**SUBMISSION OF APPLICATION FOR PERMISSION
UNDER SECTION 12A OF THE TOWN PLANNING ORDINANCE (CAP. 131)**

**TO REZONE THE APPLICATION SITE FROM "RESIDENTIAL (GROUP A)" TO
"RESIDENTIAL (GROUP A)9" FOR PERMITTED FLAT WITH SHOP AND SERVICES AND
SOCIAL WELFARE FACILITY (RESIDENTIAL CARE HOME FOR THE ELDERLY) USES
AT LOT NO. 3678 IN D.D. 120, YUEN LONG, NEW TERRITORIES**

FURTHER INFORMATION (2) – Technical clarifications

Section 12A Application to rezone the application site from "Residential (Group A)" to "Residential (Group A)9" and to amend the Notes of the zone applicable to the site (Application No. Y/YL/21)

PROPOSED STREETScape PLAN

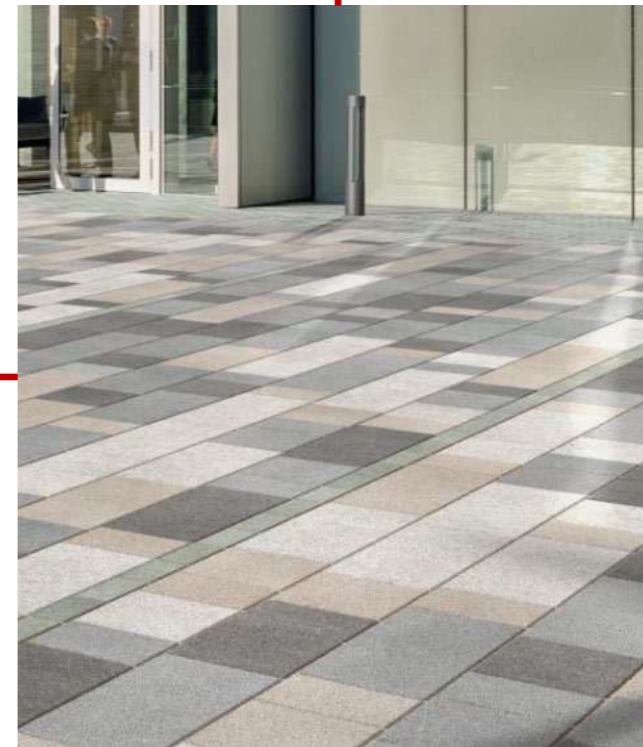
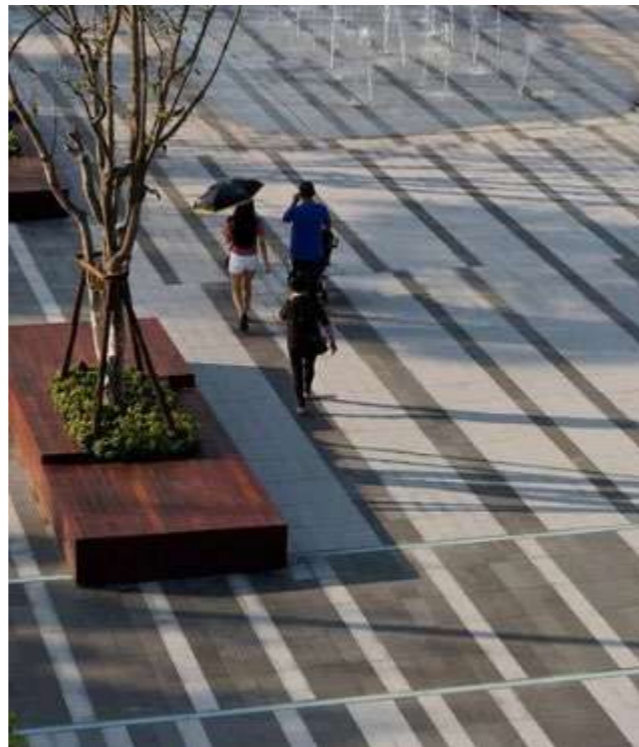
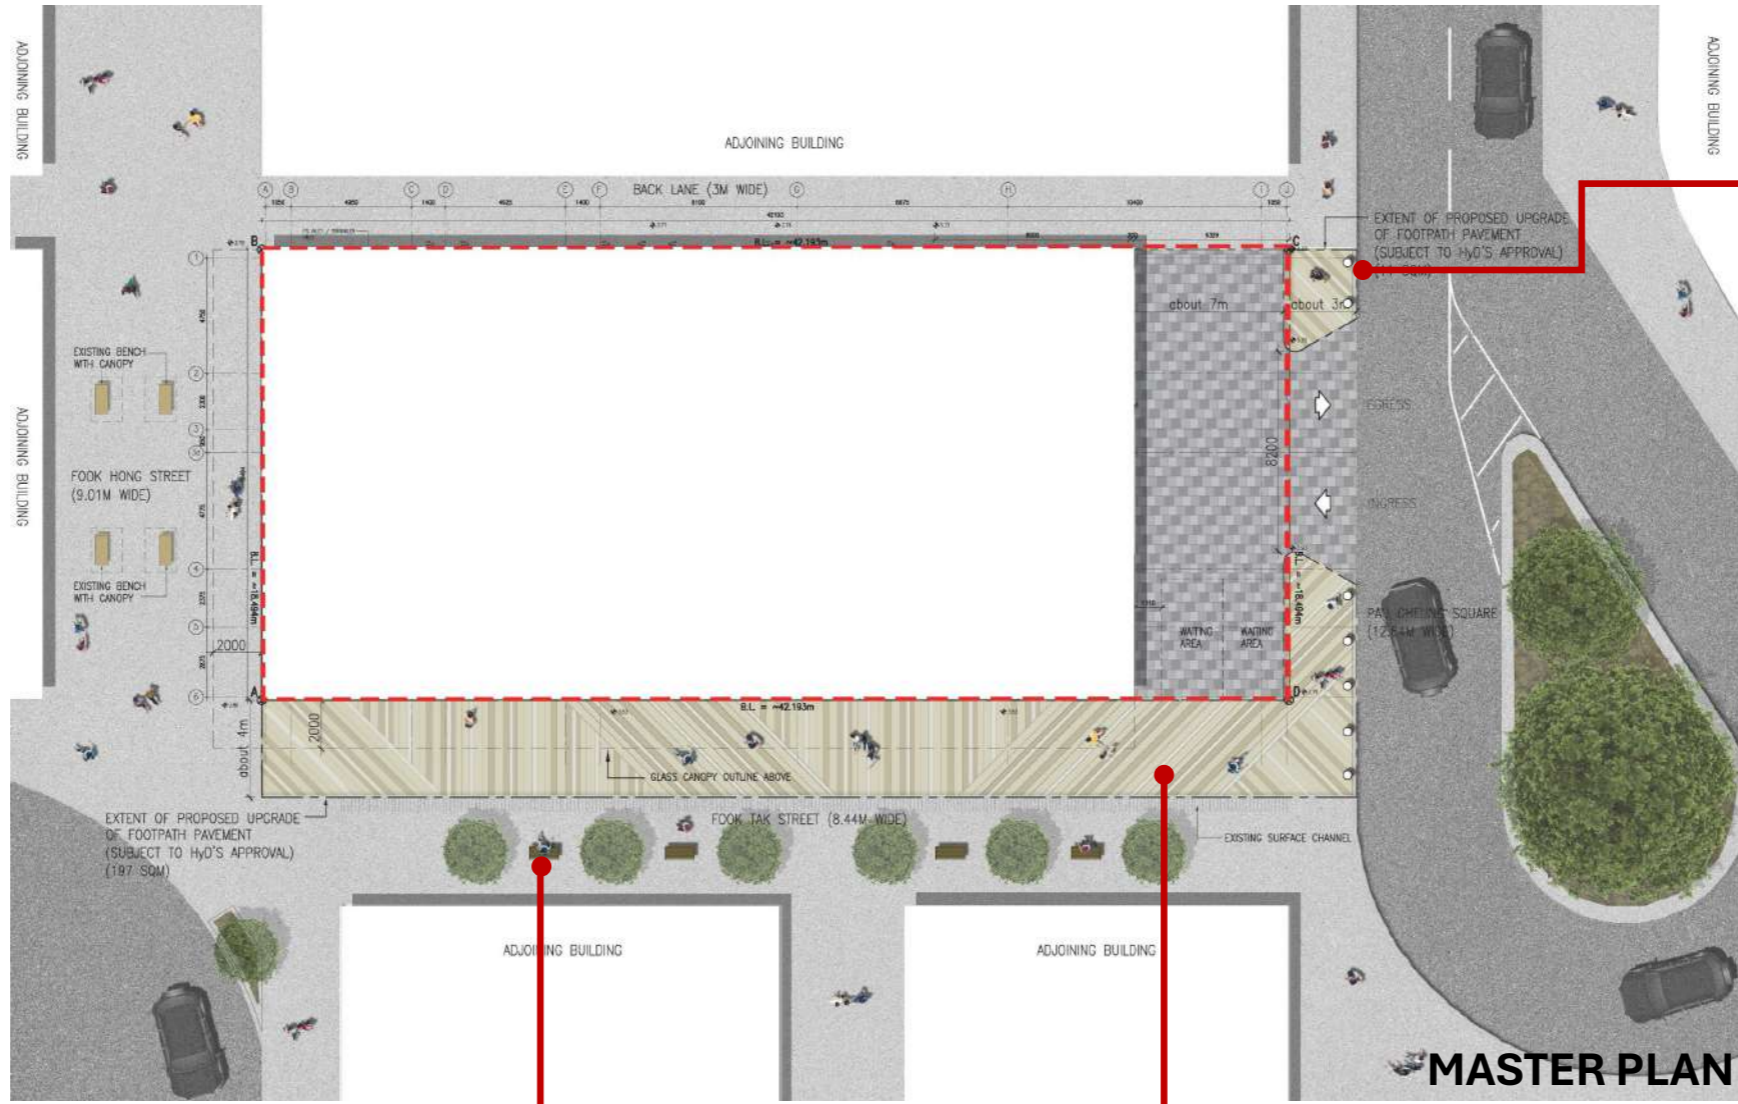
<p>2. Please provide further details on the proposed footpath upgrading works, including provision of wider canopy, a section plan of the footpath with dimensions and clarification on the future management and maintenance arrangements.</p>	<p>Attached please find the provision of wider canopy of 2m based on the specified requirements in TPDM (i.e. vertical clearance for structures over pavements is 3.5m), a section plan of the footpath with dimensions. Please be clarified that whilst the canopy is above Government land, the future M&M arrangement will be similar to the above response. The applicant will be responsible for the M&M of the canopy extruded from and as part of the proposed building.</p>

G/F LAYOUT PLAN

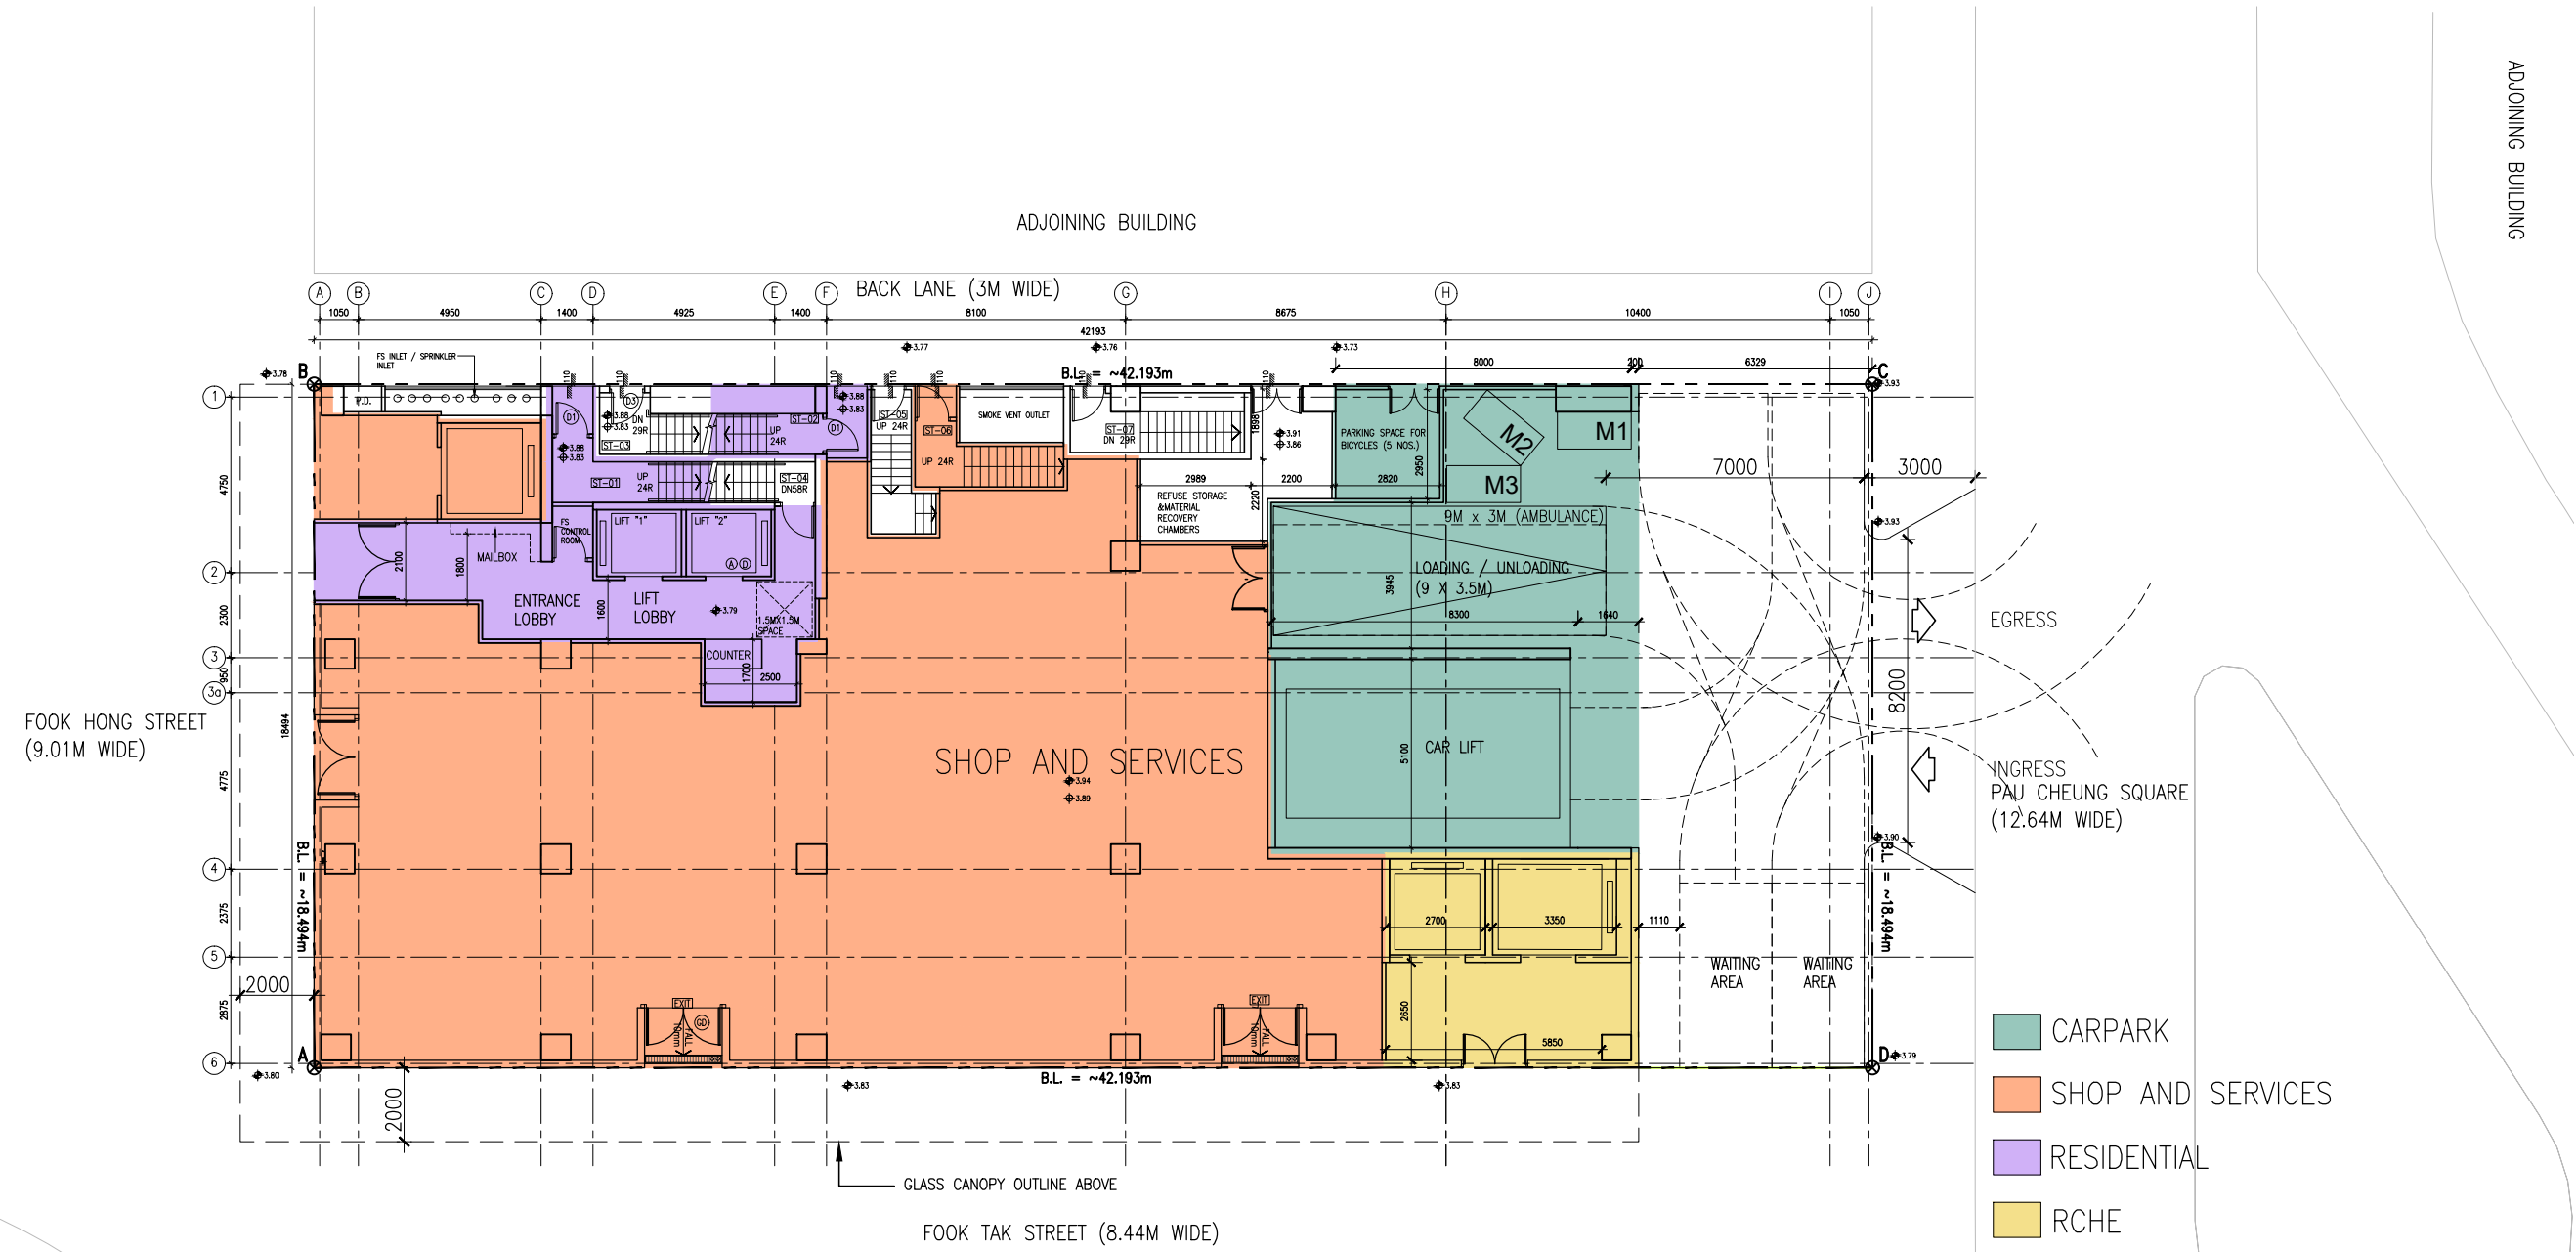
<u>2. Buildings Department</u>	
<p>No objection under the Building Ordinance (BO) subject to the demonstration of permitted site coverage in compliance with the Regulation 20 of the Building (Planning) Regulation [B(P)R]. It is noted that the proposed maximum site coverage (S.C.) of 85% as indicated in Table 4.1 of Appendix I may exceed the permissible S.C. under the 1st schedule of the B(P)R.</p> <p>The applicant may wish to clarify the above, with consideration of the facilitating measures available under Practice Notes for Authorized Persons, Registered Structural Engineers and Registered Geotechnical Engineers (PNAP) APP-172 and APP-132 allowing the applicant to apply for modification of relevant provisions under the BO to provide residential care homes for the elderly (RCHE) and allow for greater flexibility in the design of the proposed development respectively as appropriate.</p>	<p>The building setback in compliance with SBDG is a pre-requisite for GFA concessions under PNAP APP 151 and PNAP APP 152. The building set back accounting for 15% of the site under the submitted scheme looks fulfil the following requirements of SBDG:</p> <ul style="list-style-type: none"> a) Full height and full frontage setback of the building from the site boundaries abutting any narrow streets from the respective site boundaries with a total setback area which is not less than 15% of the area of the site provided that such area will contribute to improving the street environment; and b) For small sites not exceeding 1,000 m², greenery should be provided at the Primary Zone such that the greenery area is not less than 50% of the setback area. All greenery areas shall comply with the requirements in Appendix D where applicable. <p>The Site Coverage from G/F to 9/F are hence maximized to 85%.</p> <p>Uses for habitation are regarded as domestic uses under the BO. Despite that, as per PNAP APP-172, the BA may grant modifications to treat a RCHE or RCHD as a non-domestic part of a composite building for the purposes of regulations 19, 20, 21 and 22 of the Building (Planning) Regulations (B(P)R). The Applicant will make an application for such modification at the building plan submission stage.</p> <p>Aside from that, on application to the BA for a modification in pursuit of PNAP APP-132, the BA is in principle prepared to consider</p>

<p>applications for more flexible application of the requirements under Regulations 20 and 25 of the B(P)R, allowing the site coverage of a non-domestic building at different levels to vary according to the height of the level within the percentages set out in the tables at Appendix B thereof. G/F to 9/F of the proposed scheme is situated at a height level of below 35m from street level, which the site coverage can be permitted up to 85%</p>
<p><u>3. Planning Department</u></p>	
<p>1. Please note that in considering planning application no. A/YL/319, the Board Members commented there is no detailed information, including the future management were provided on the proposed footpath upgrading works at Yuen Long Pau Cheung Square and Fook Tak Street. Please refer to the extract of minutes enclosed.</p>	<p>The Applicant will be responsible for the upgrading works of the proposed footpath on Government land. Subject to detailed design and the later Lease Modification application, the land of which is normally granted to the Applicant on a temporary basis for carrying out the upgrading works governed by appropriate land lease/tenancy documents. Upon completion of the upgrading works, footpath area will be required to be redelivered to the Government for future management under the conditions of the relevant land documents.</p>

Pages 8 and 9 of the Catalogue of the Double
Rack Parking System

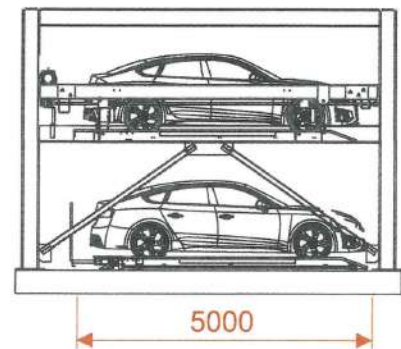
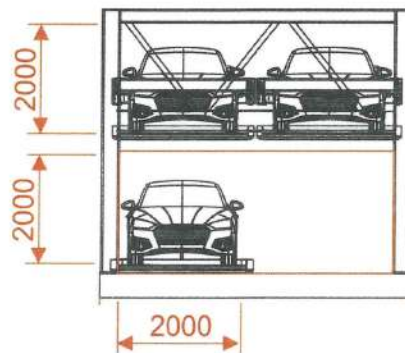
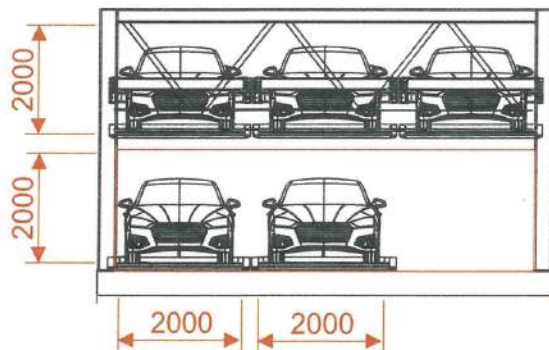
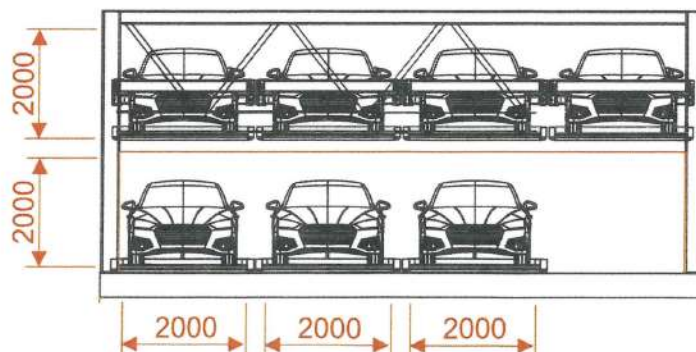
1. RtC (d): The design of mechanical parking system in Annex B consists of 3 levels of parking spaces which is inconsistent with the proposed double decking scheme. Please also make reference to Table 7.4.6.1 of TPDM Volume 7 Chapter 7 for the minimum requirement.	<p>Please find an additional page supplemented to the catalogue with the design of 2-level mechanical parking system in Appendix 10.</p> <p>According to the catalogue (p.8 re-attached in Appendix 10), the specified length, width, height and loading for vehicles are 5m, 2m, 2m, and 2,500kg respectively. As such, the length, width, height and loading for vehicle as specified on the table all fulfill the respective TPDM requirements.</p>
The Traffic Impact Assessment report should be updated for our review.	Noted. A consolidated version of the latest TIA report will be sent for TD's review which reflects all the previous R-toCs.
